## **ADDENDUM #2**

Date: May 14, 2015

**ADDITION & REMODEL  
KENWORTH SALES - JEROME  
JEROME, IDAHO**

**ADD 2.1**

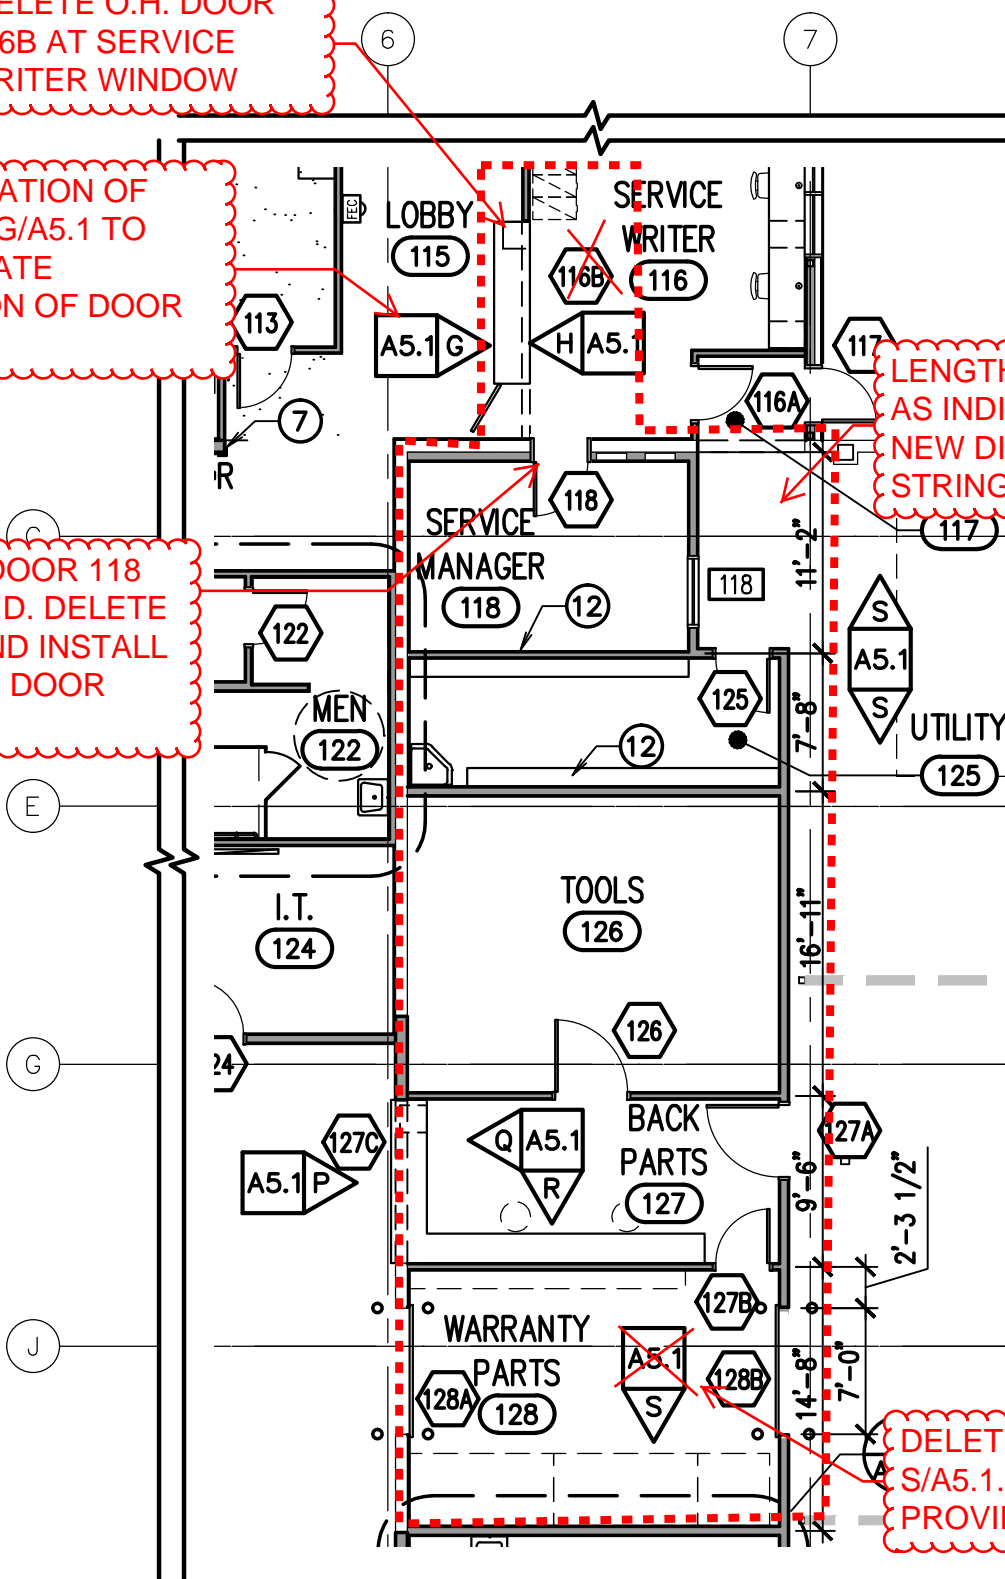
1. Sheet A1.2, Floor Plan:  
Adjust location of walls in service managers 118, Utility 125, tools 126, as indicated on attached sketch Add 2.1
2. Sheet A1.2, Floor Plan & A5.1 Casework Elevations:  
Adjust location of Casework G/A5.1 into Lobby 115 by 24" to accommodate new door 118 location. Also delete coiling counter door 116B.

4. Sheet A1.2, Floor plan;  
Delete Casework S/A5.1 in Parts Warranty 128. Owner will provide shelving. Reduce width of coiling overhead door to 7'-0"w. and adjust location in wall indicated on attached sketch Add 2.1.

5. Sheet A1.2, Floor Plan;  
Adjust location of Window 123 s indicated on attached sketch ADD 2.1
6. Sheet A1.2, Floor plan;  
Add window blinds to Windows 118 and 123.

DELETE O.H. DOOR  
116B AT SERVICE  
WRITER WINDOW

ADJUST LOCATION OF  
CASEWORK G/A5.1 TO  
ACCOMMODATE  
INSTALLATION OF DOOR  
118

RELOCATE DOOR 118  
AS INDICATED. DELETE  
SIDE LITE AND INSTALL  
HALF LITE IN DOOR  
PANEL

LENGTHEN ROOMS  
AS INDICATED BY  
NEW DIMENSION  
STRING

DELETE CASEWORK  
S/A5.1. OWNER WILL  
PROVIDE SHELVING

**ADD 2.3**

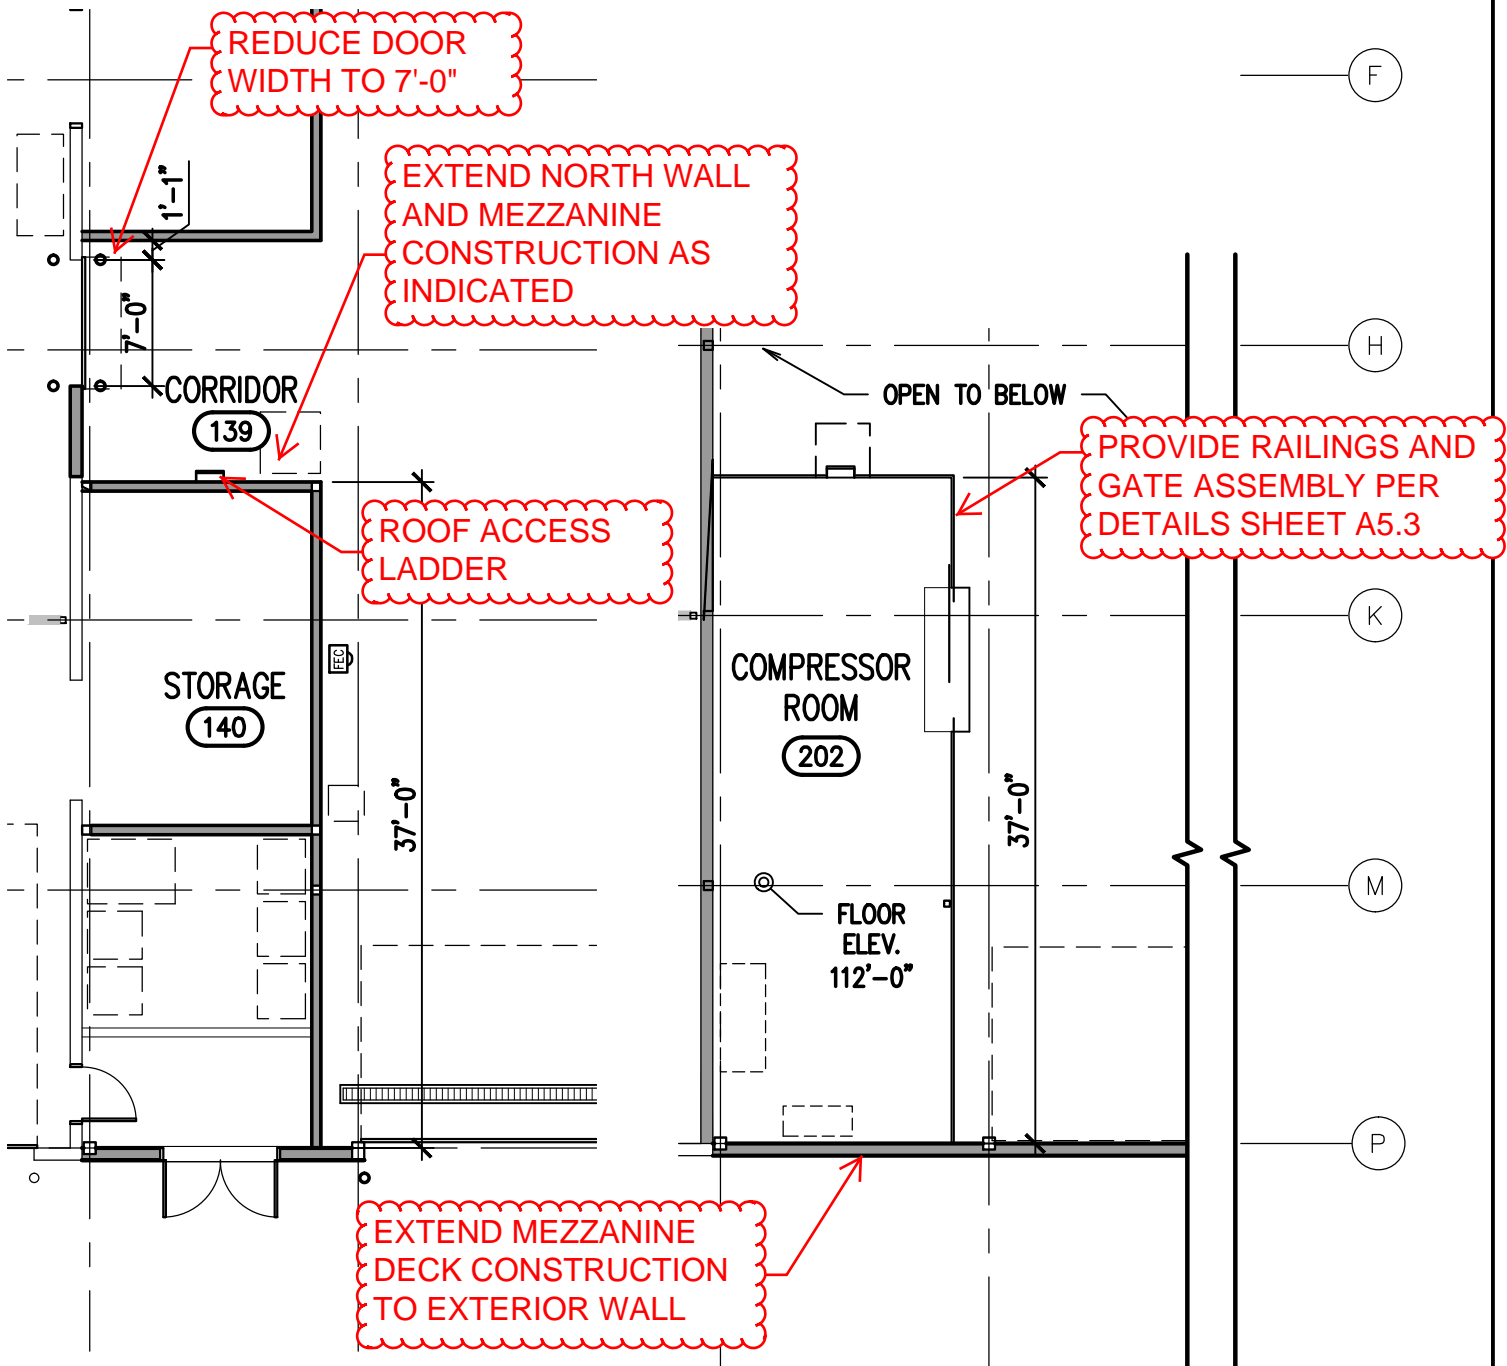
14. Sheet A1.2, Floor plan;  
Reduce width of OH door 139 to 7'-0" and locate in opening as indicated on attached sketch ADD 2.3.

**ADD 2.4**

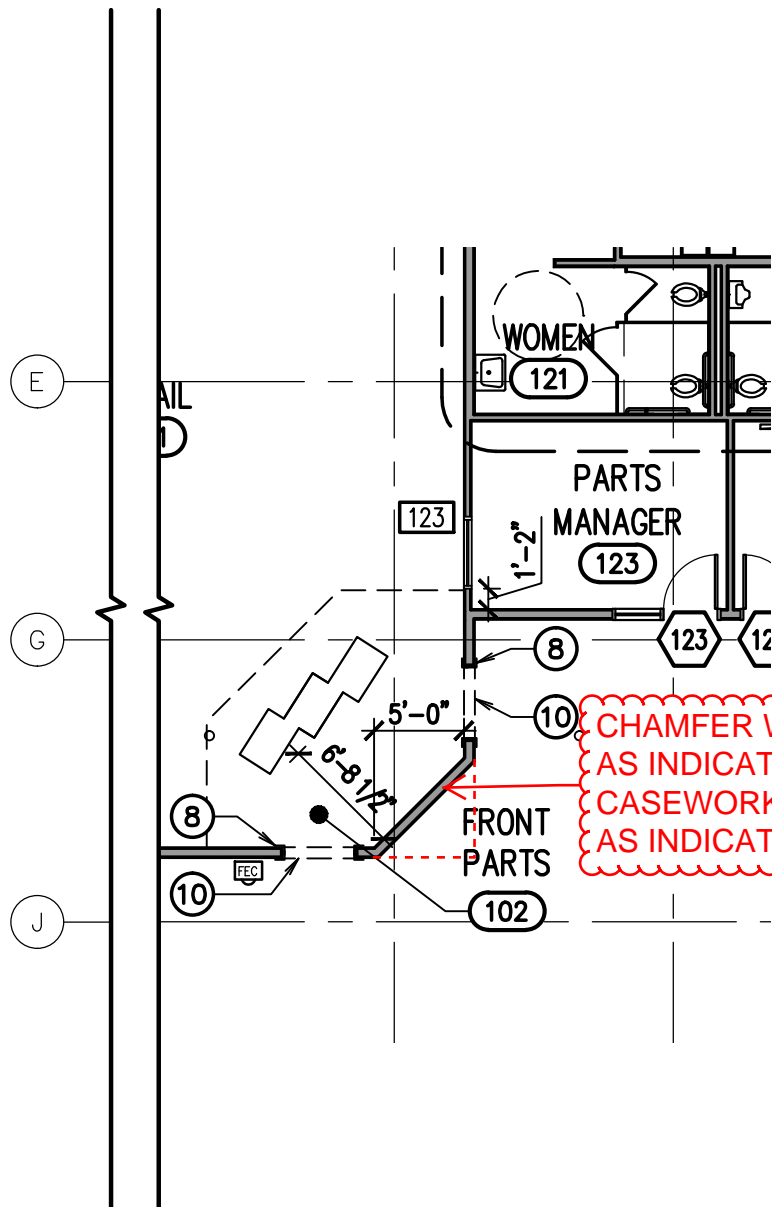
7. Sheet A1.2, Floor Plan;  
Modify (chamfer) wall behind front Parts counter, relocate casework A/A5.1, B/A5.1 and U/A5.1 and soffit above as indicated on the attached sketch ADD 2.4.

**ADD 2.6**

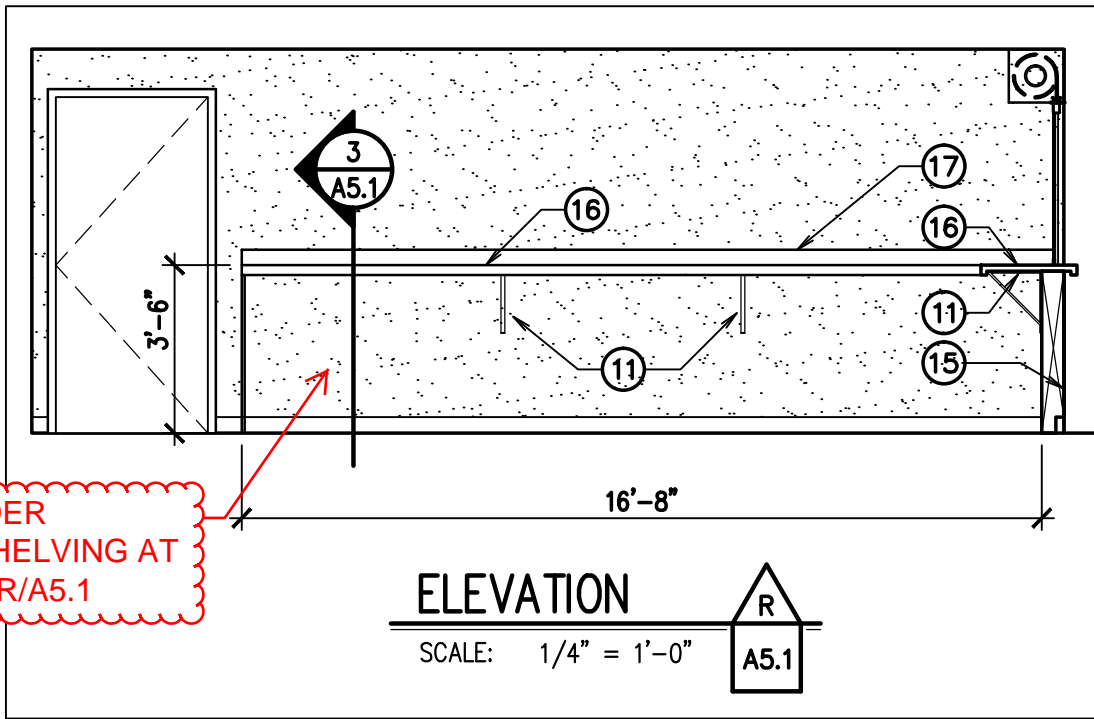
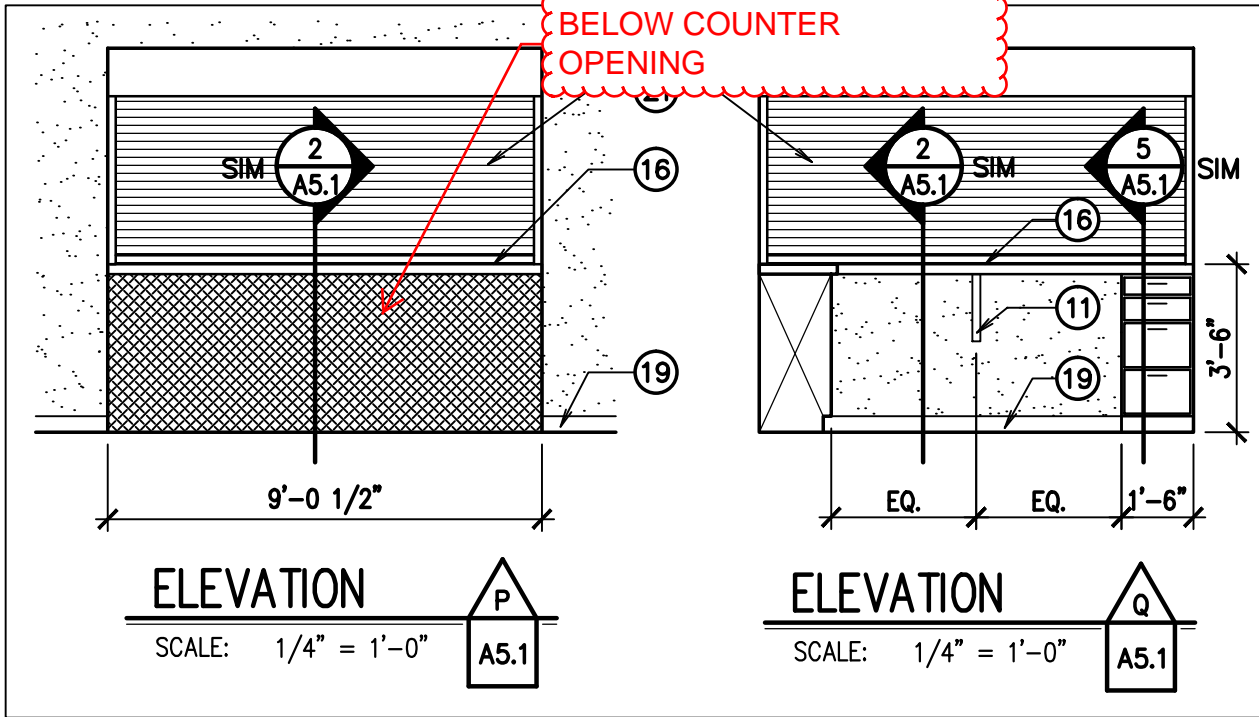
3. Sheet A5.1, Casework Elevations;  
Delete under counter shelving from casework item R/A5.1. See attached sketch ADD 2.6. Wall below counter shall be paint dark in color W/ Black vinyl base

PROVIDE DIAMOND PLATE  
BELOW COUNTER  
OPENING

DELETE UNDER  
COUNTER SHELVING AT  
CASEWORK R/A5.1

DRAWING NO.:  
**ADD 2.7**  
SCALE:  
3/32" = 1'-0"

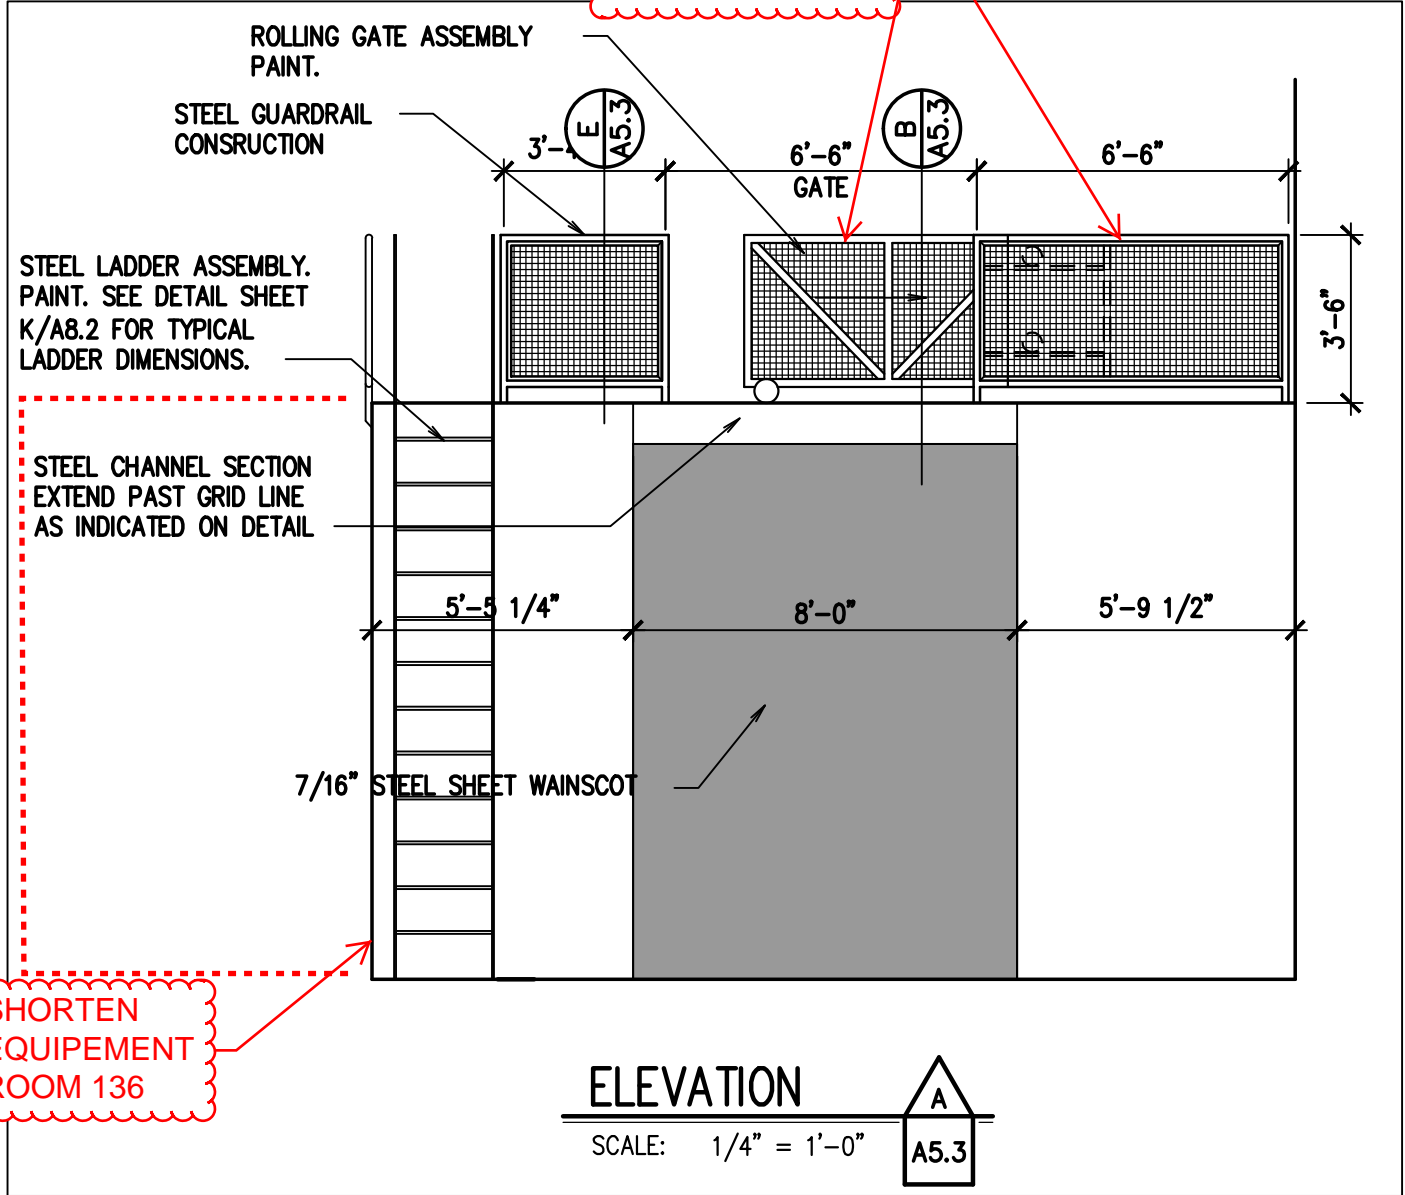
ADJUST  
RAILINGS AND  
GATE ASSEMBLY

**Model: RPSS-RT Retrofit Safety Screen for Installation at Top of Roof Curbs**

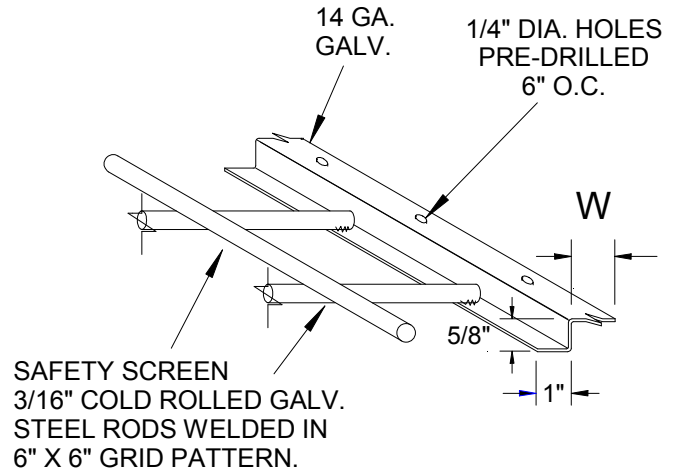
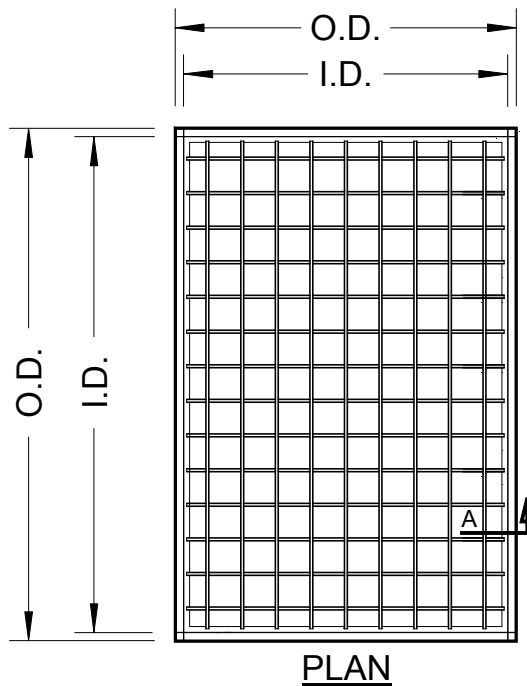
10. Sheet A1.2, Floor Plan;  
Add (2) additional fire extinguishers as specified. Locate one at Warehouse 135 and one next to entrance to paint booth.
11. Sheet A8.1, Roof Plan;  
At all skylight locations provide and install fall protection as indicated in attached Data and specification sheets.
